Addendum No. 3

Austin Masjid
800 N Heatherwilde Blvd., Pflugerville, TX 78660
June 4, 2026

Project Number: 2305

NARRATIVE OF ELECTRICAL REVISIONS

1 SECOND FLOOR POWER PLAN
E2.01 SCALE : 1/8" = 1'-0"

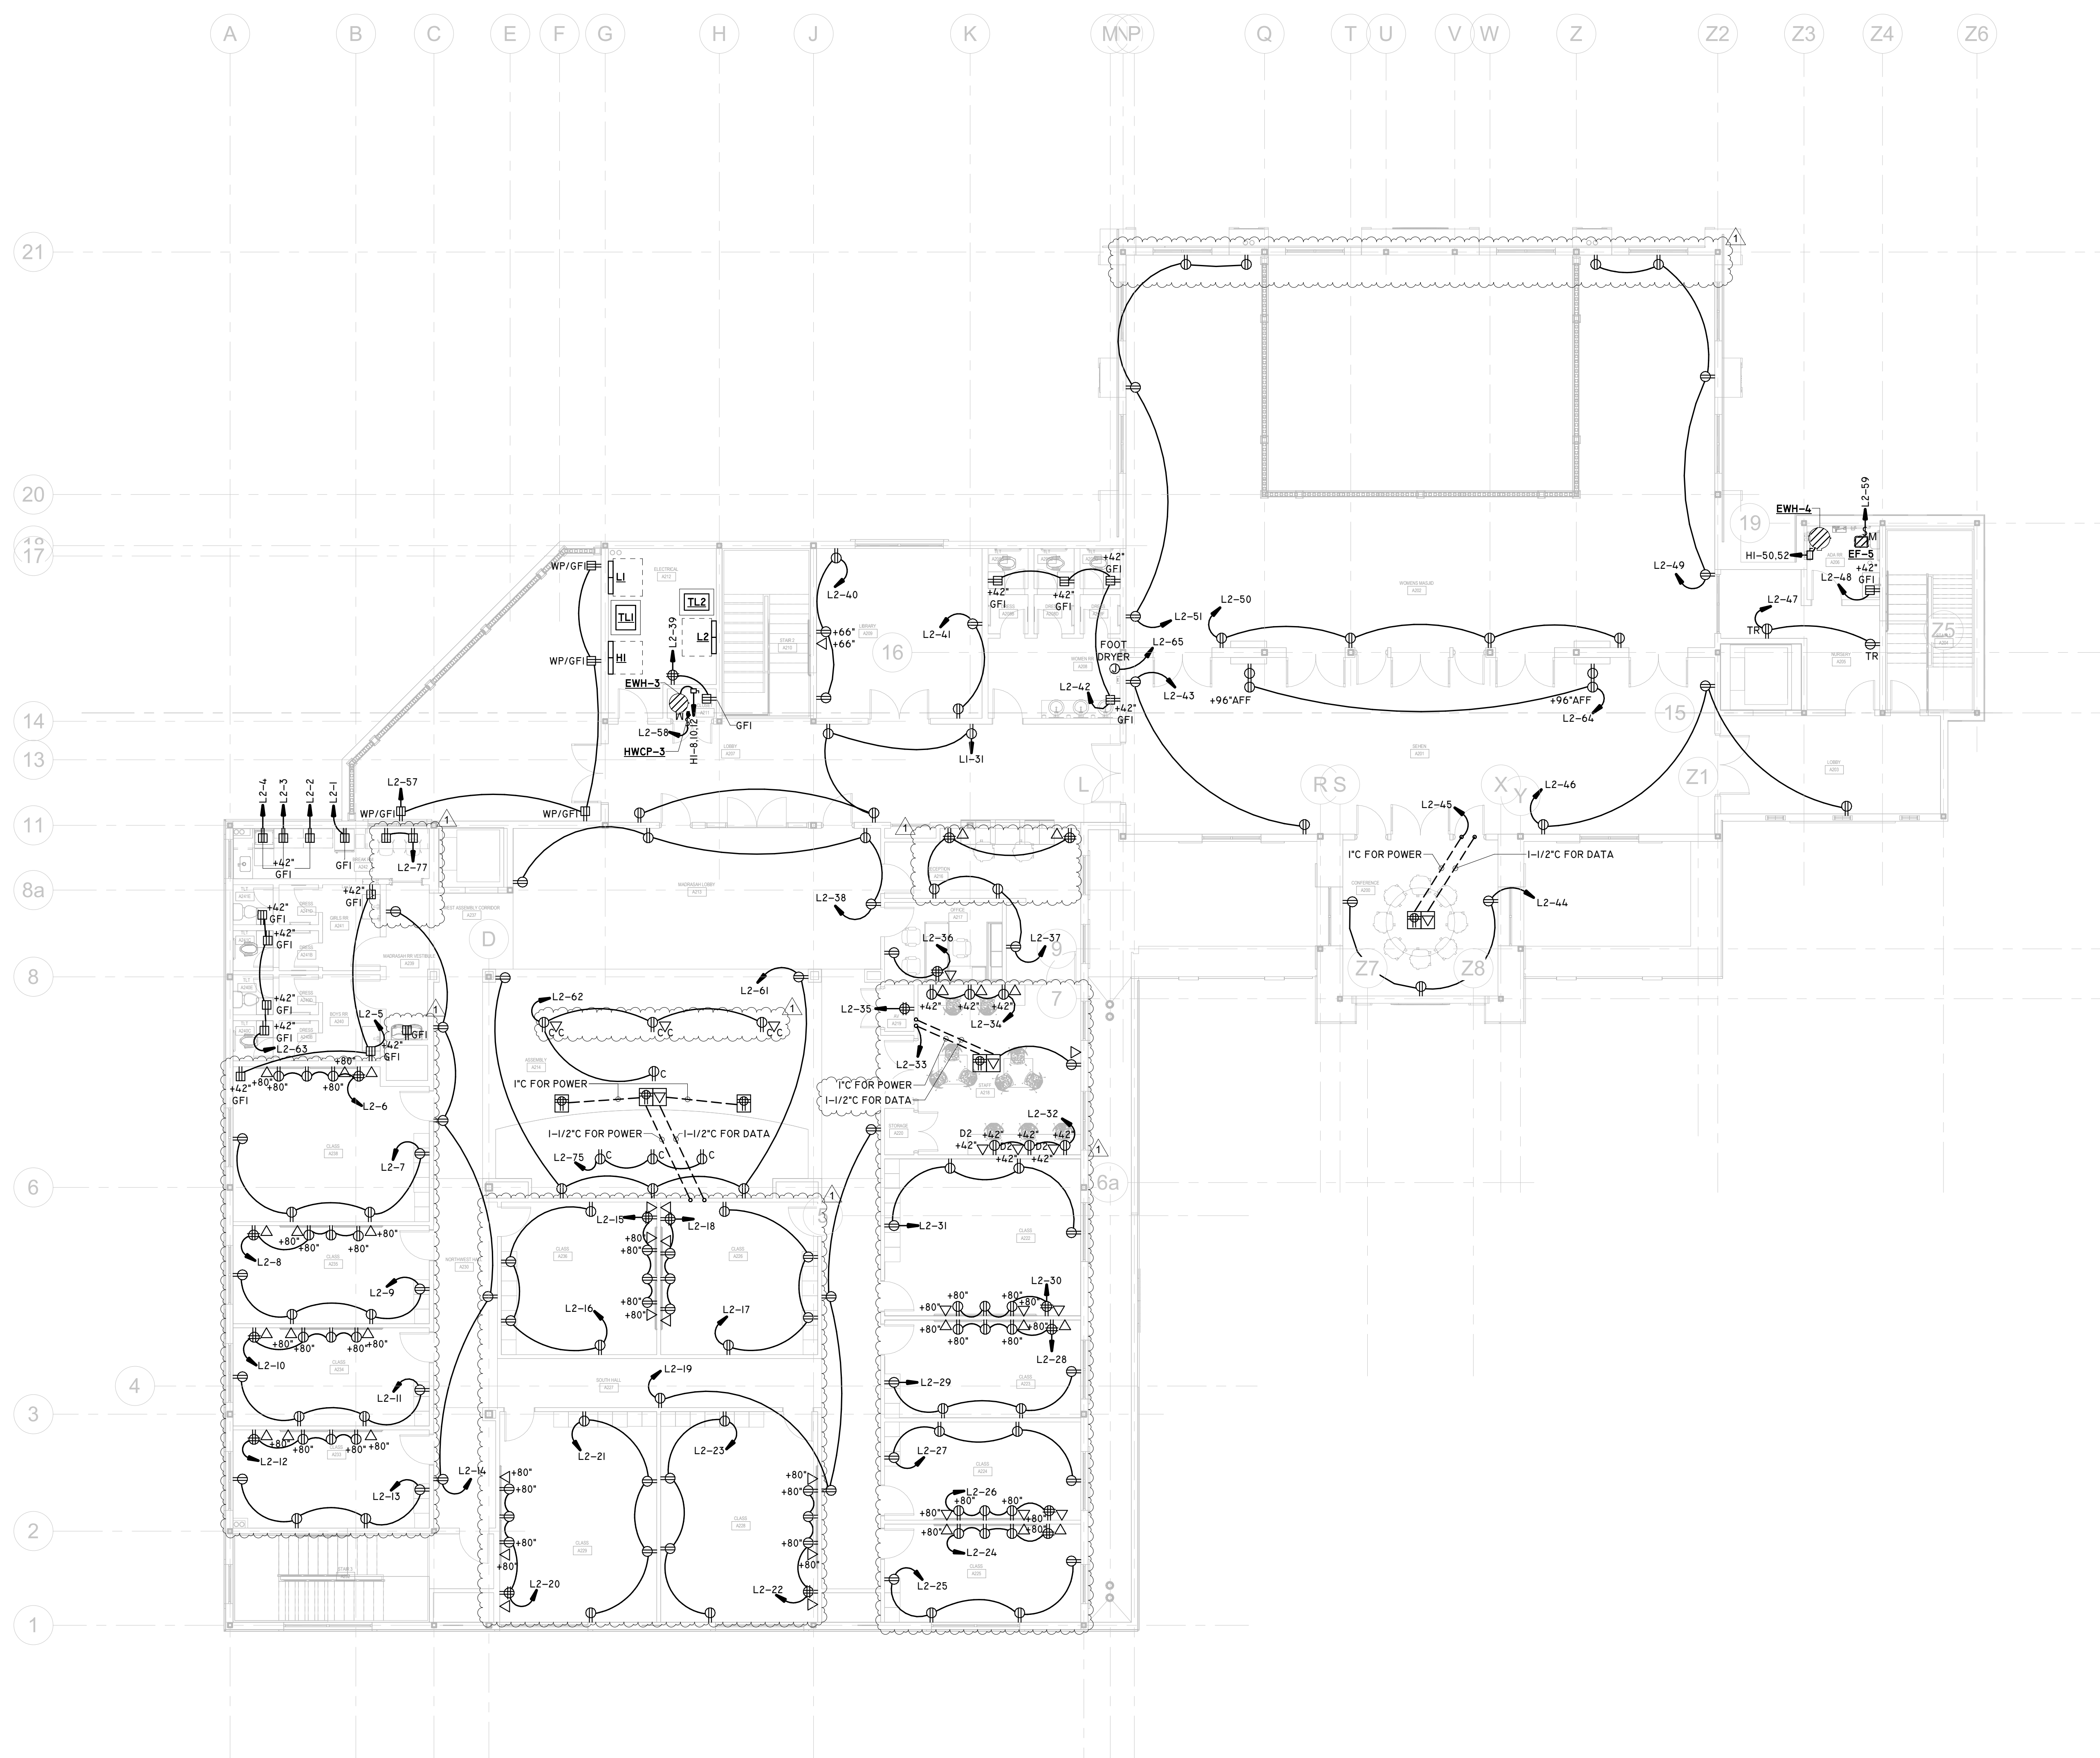
- Added various power and data outlets to clouded areas for coverage.

1 FIRST FLOOR LIGHTING PLAN
E3.00 SCALE : 1/8" = 1'-0"

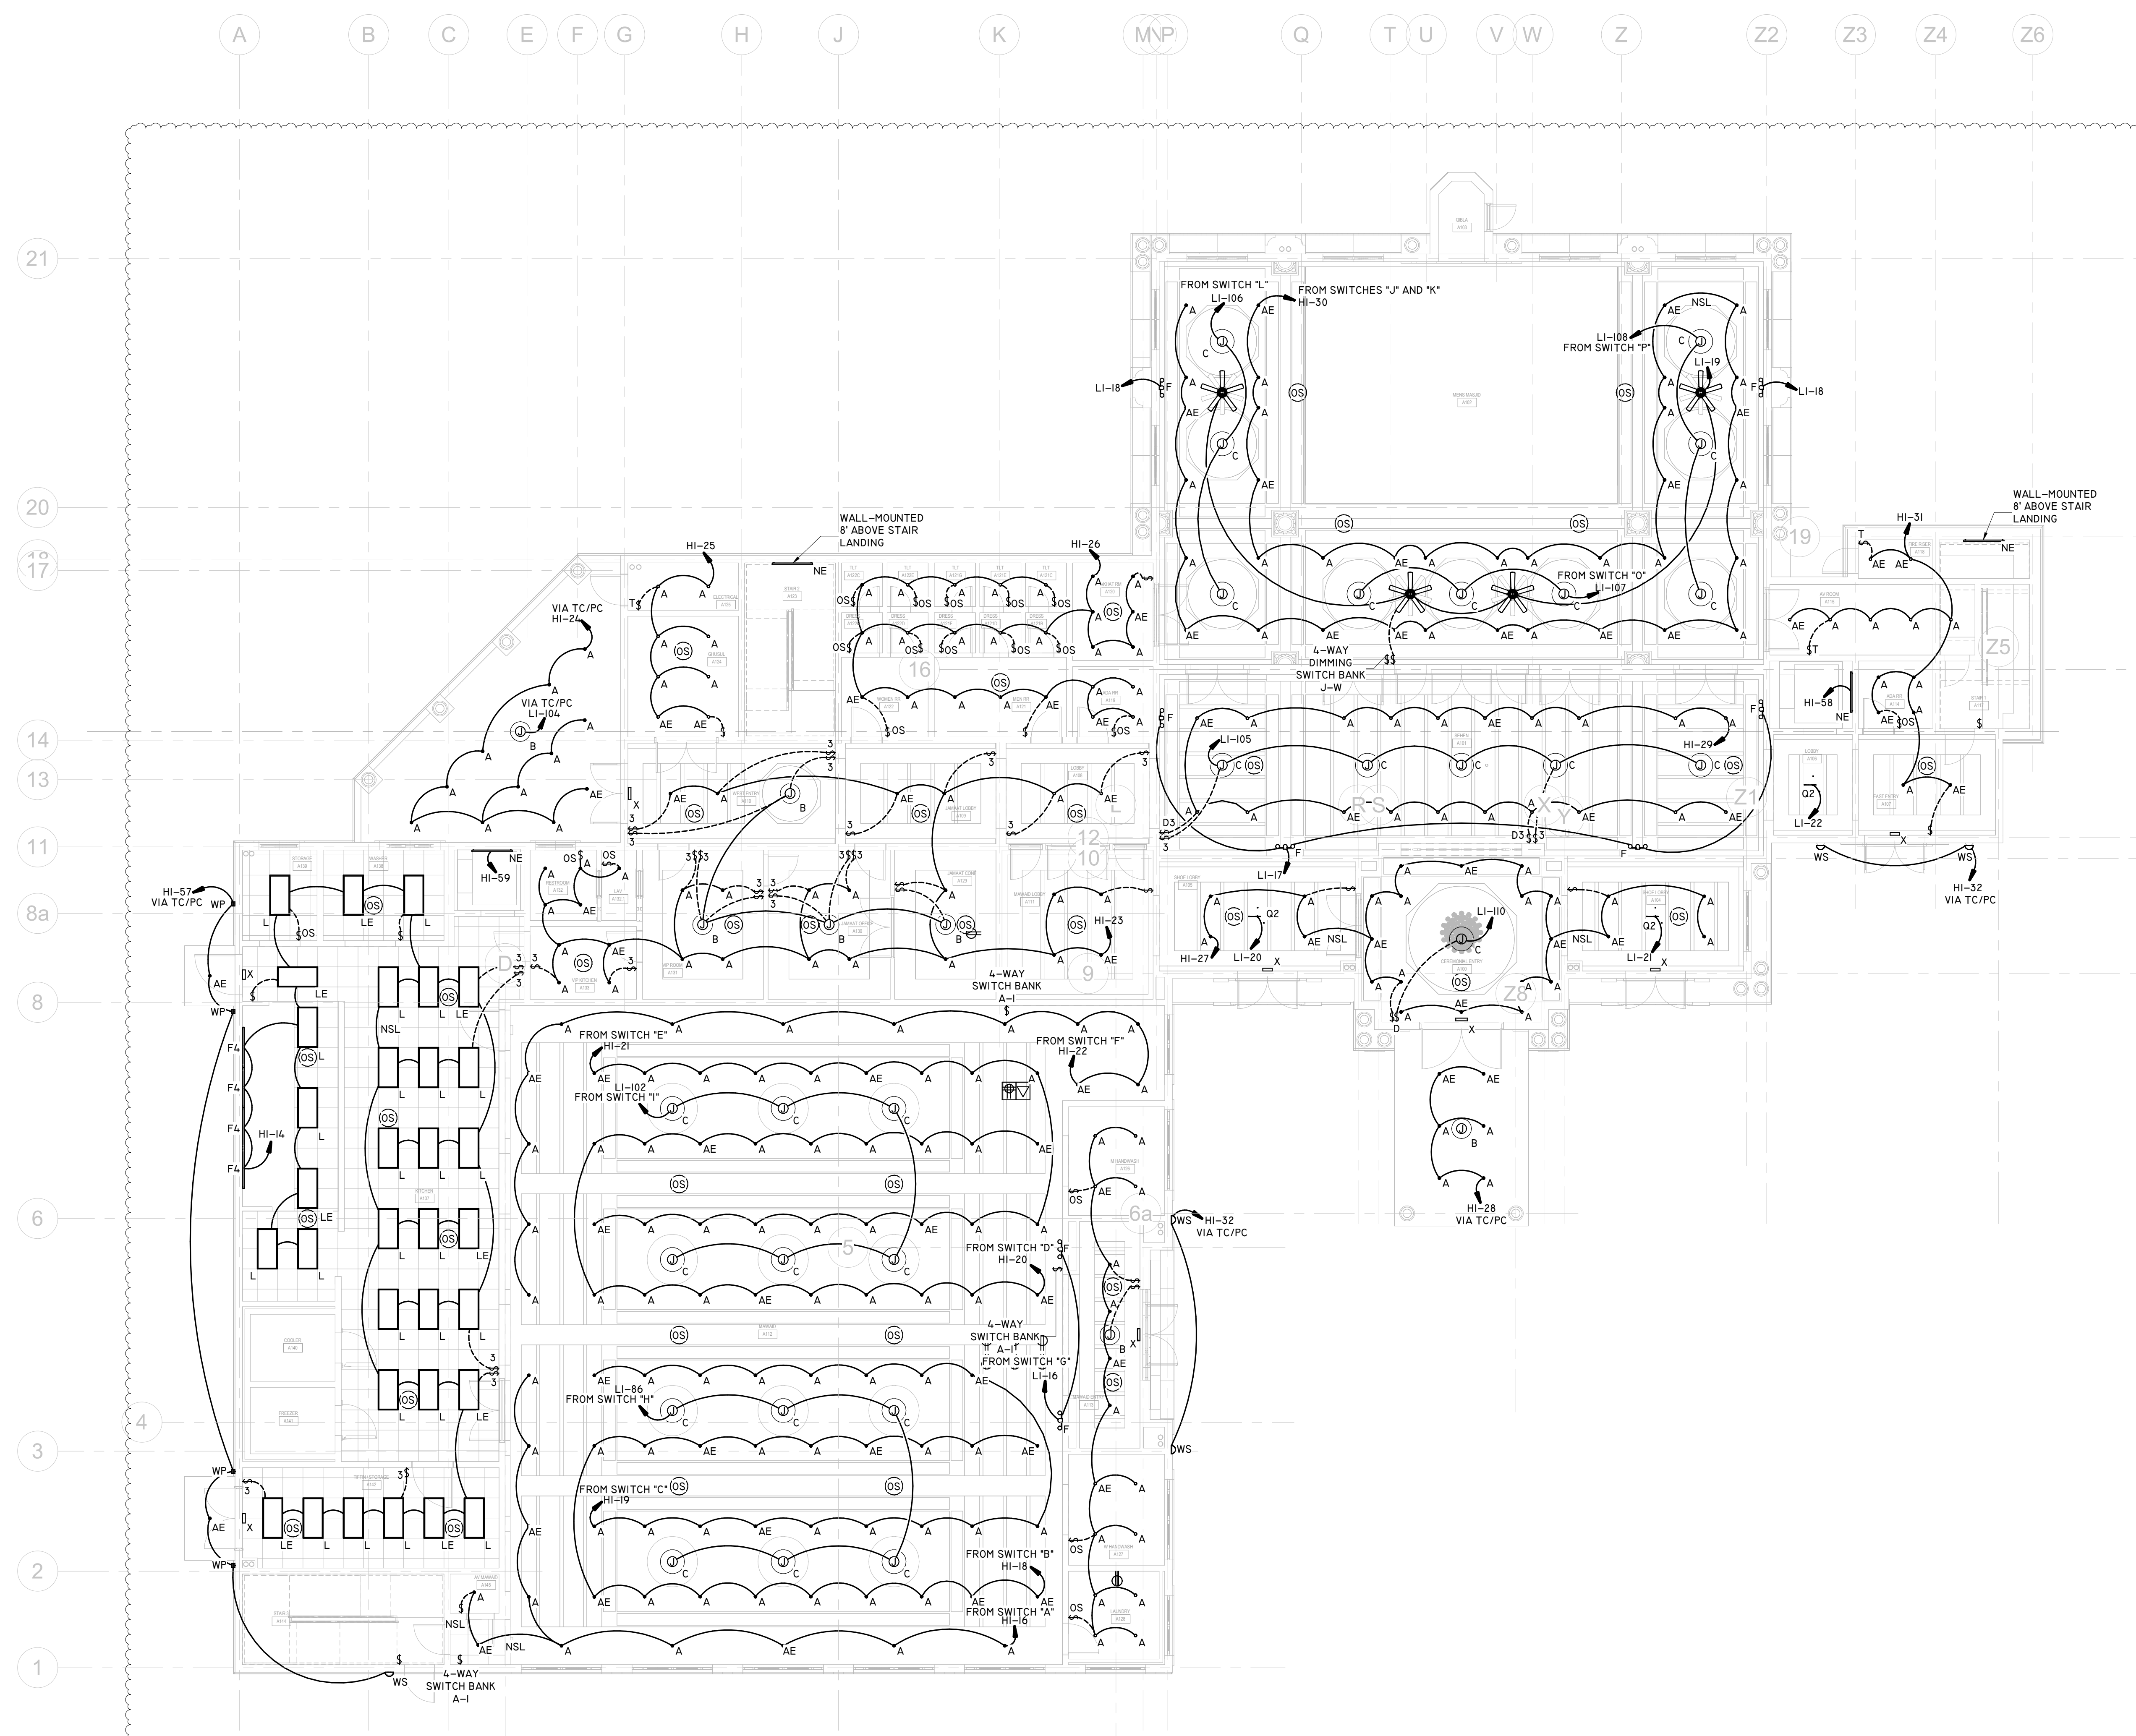
- Added wall pack lighting.
- Added emergency lighting throughout.
- Added switching and power to chandelier in the ceremonial entry.

SITE PHOTOMETRIC

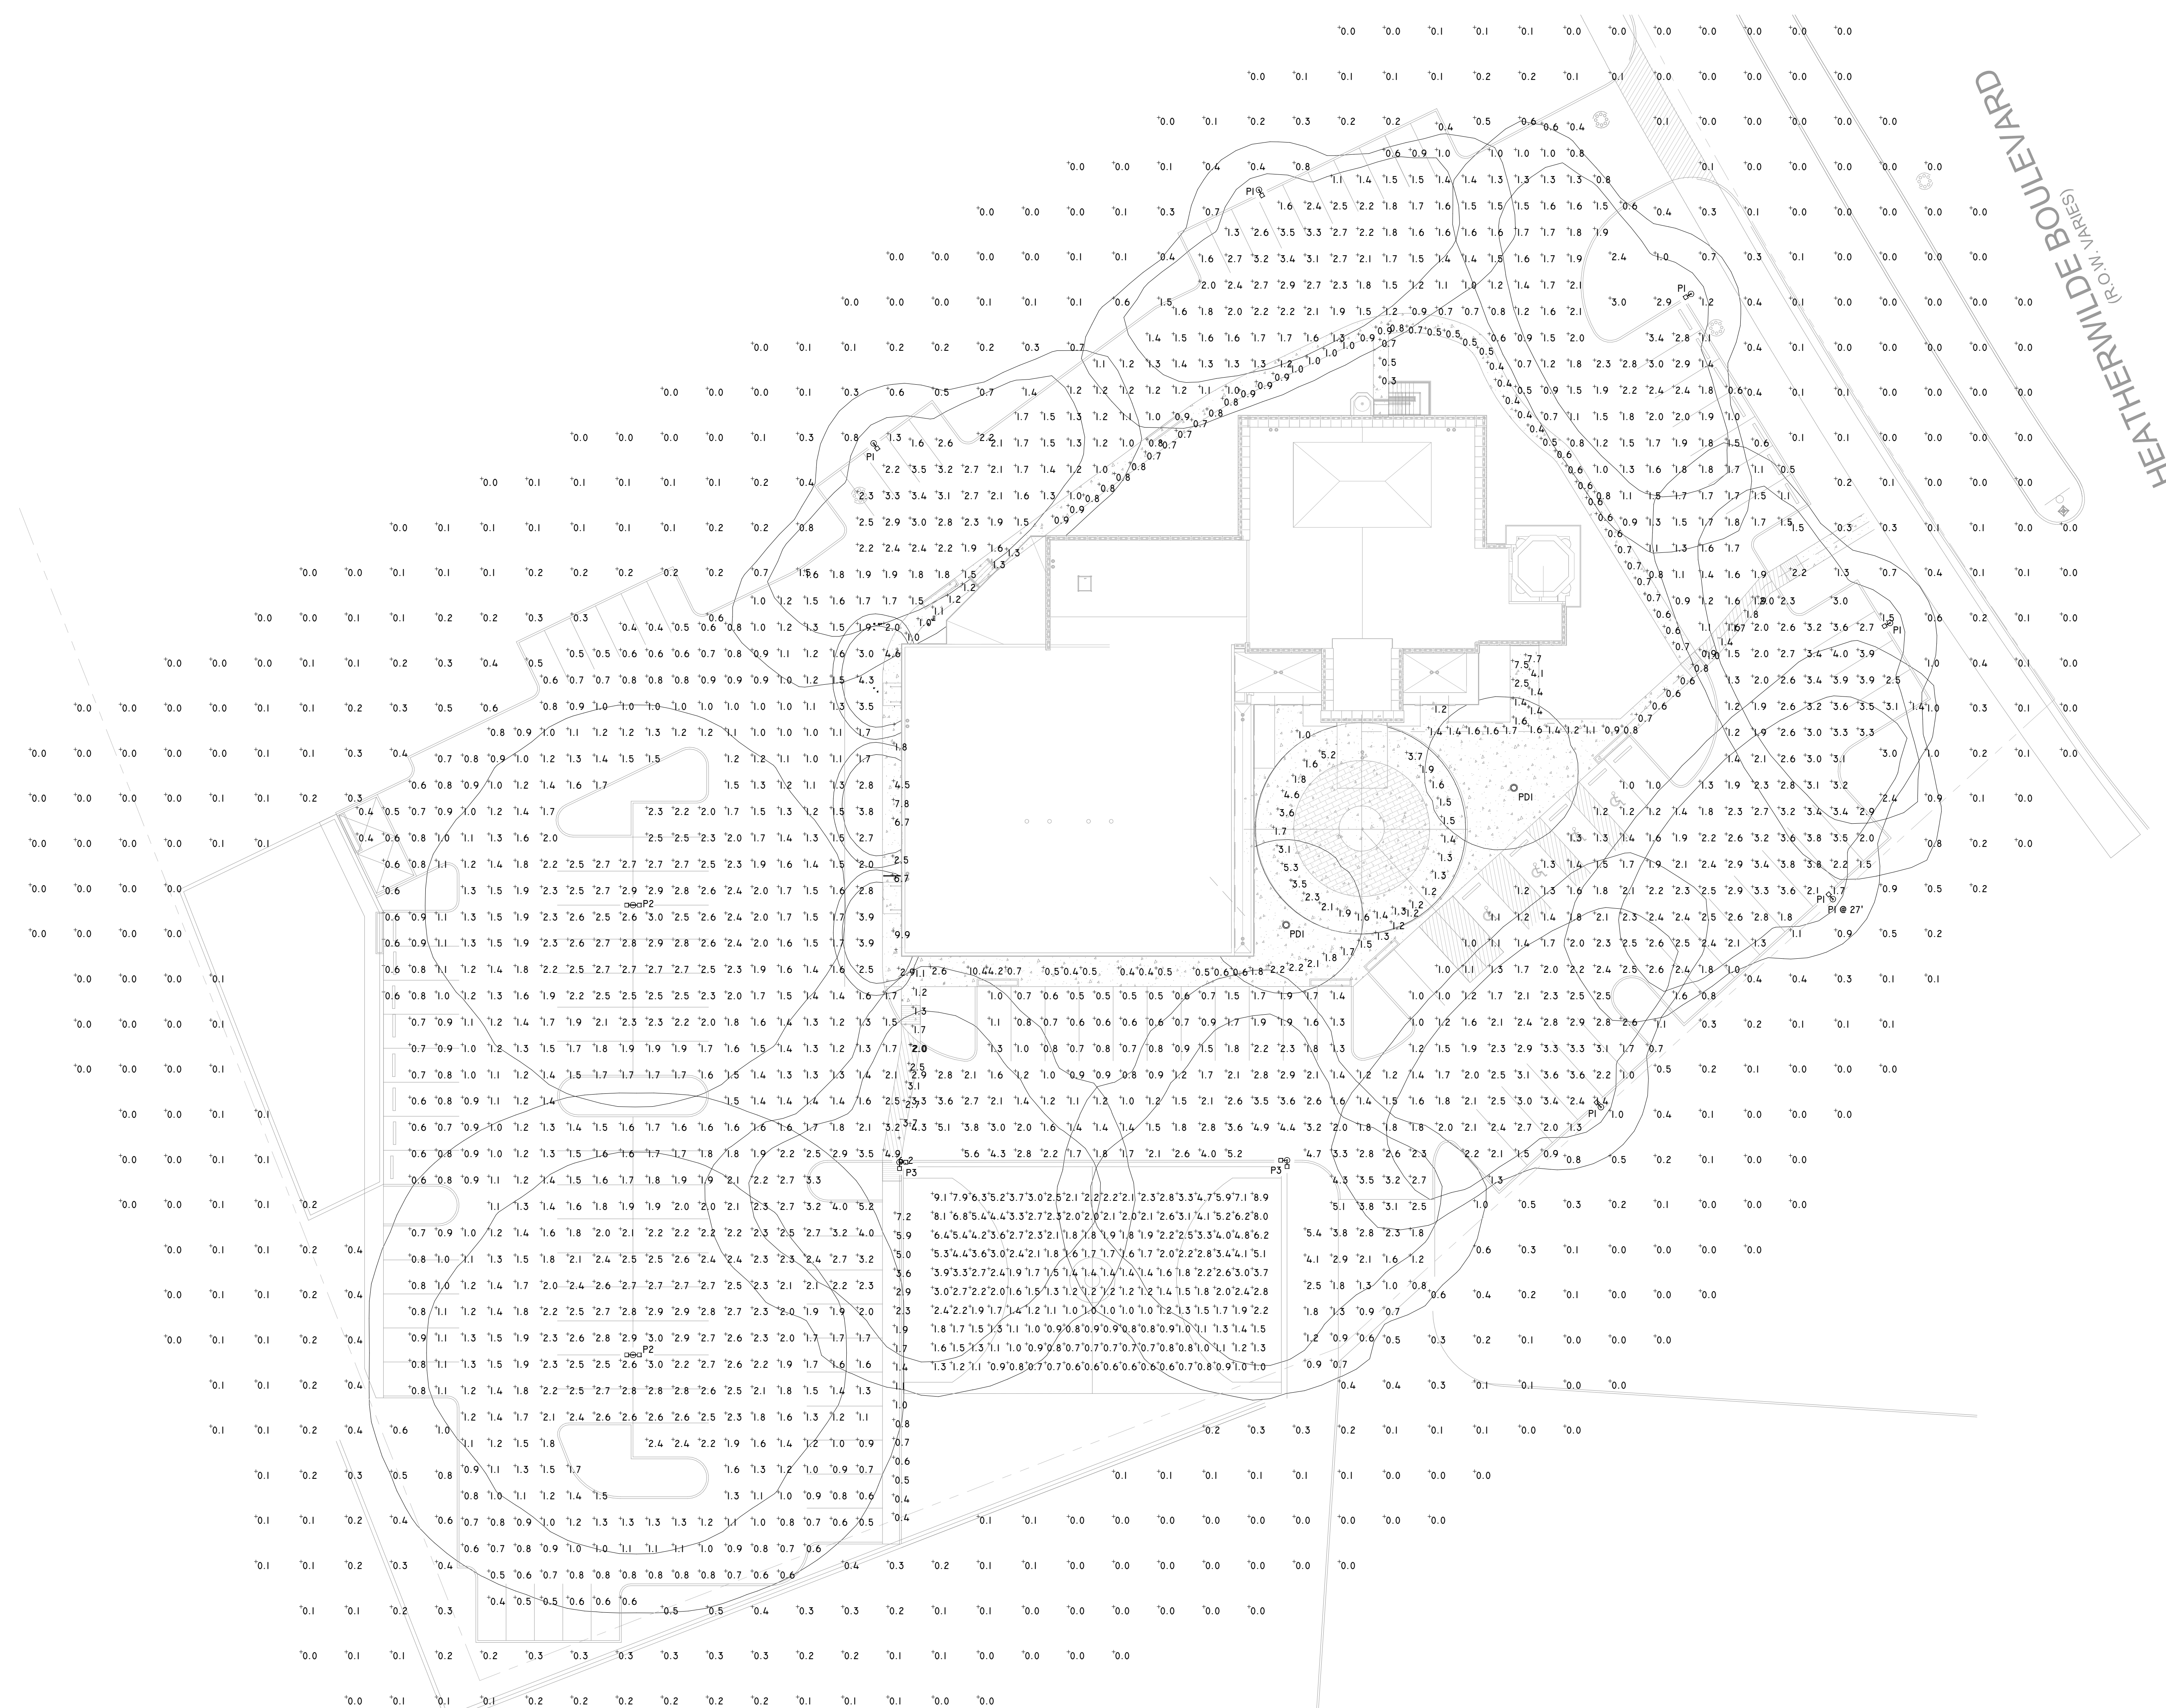
- Added site photometric calculation sheet.
